MANDATORY SERVICE BULLETIN Z 142/40a, Z 43/39a

- 1. DATE:** May 31, 1998
- 2. MODELS AFFECTED:** The following Z 142 and Z 43 aircraft, where the hoses in the Pitot-static system have been replaced by manufacturer with silicon hoses 5x2 068.9 ČSN 34 6554.
Z 142 aircraft S/N 0229, 0262, 0266, 0286, 0327, 0334, 0341, 0357, 0358, 0363, 0371, 0379, 0384, 0401, 0408, 0417 a 0467.
Z 43 aircraft S/N 0007, 0024, 0031, 0044, 0073 a 0081

- 3. SUBJECT:** Possibility of passage loss through the hose connected to the Pitot-static probe caused by excessive deformation of this hose and resulting in the malfunction of the speed measuring system.

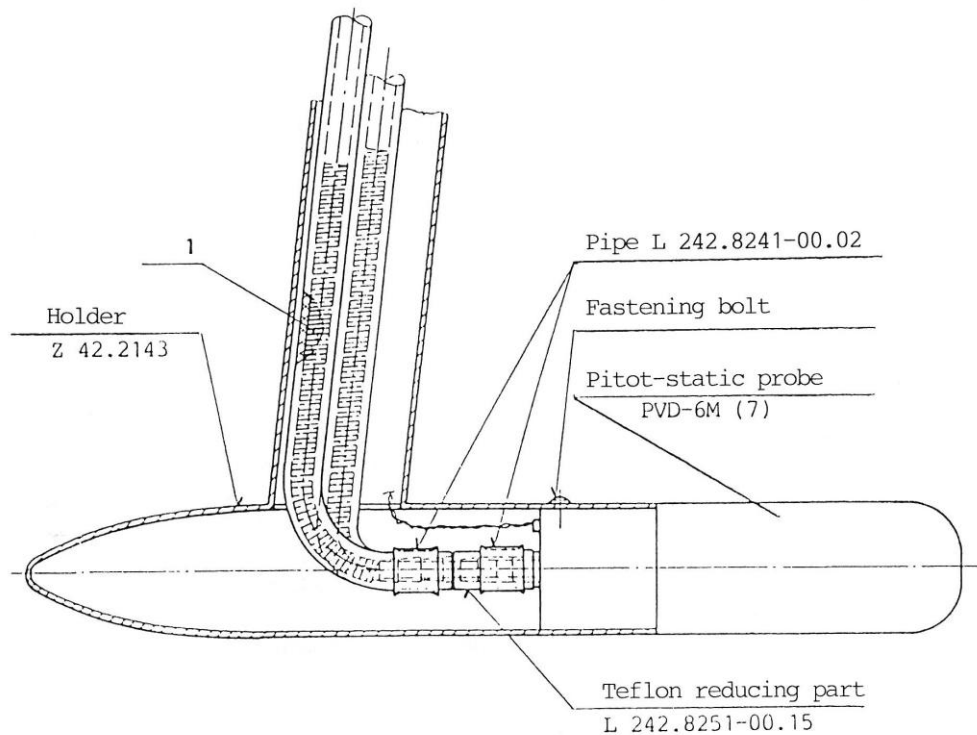
- 4. CORRECTION:** Modifying Pitot-static system of the aircraft.
- 5. TIME OF COMPLIANCE:** At the next 100-hour or annual inspection of the aircraft.
- 6. CORRECTION PERFORMED AND EXPENSES COVERED BY:** The Operator.
For the aircraft where the hoses were replaced by the Manufacturer, the necessary material will be supplied by the Manufacturer free of charge in the appendix of this bulletin.

- 7. PROCEDURE:**
1. Unscrew the three bolts fastening the Pitot-static probe, slip the probe out of the holder (at the same time loosen the inlet hoses from the other side of the holder).

2. Slip the inlet hoses of Pitot and static pressure out of the teflon reducing parts. Insert the distance spirals L 242.8251-00.14 (pos. 1) inside both the hoses. The hoses connect back to the teflon distance pieces struck on the probe.

3. Slide the Pitot-static probe back into the holder carefully pulling the inlet hoses step by step from the other end of the holder at the same time. Screw the three bolts fastening the Pitot-static probe.

4. Check the leakage of the Pitot-static system.
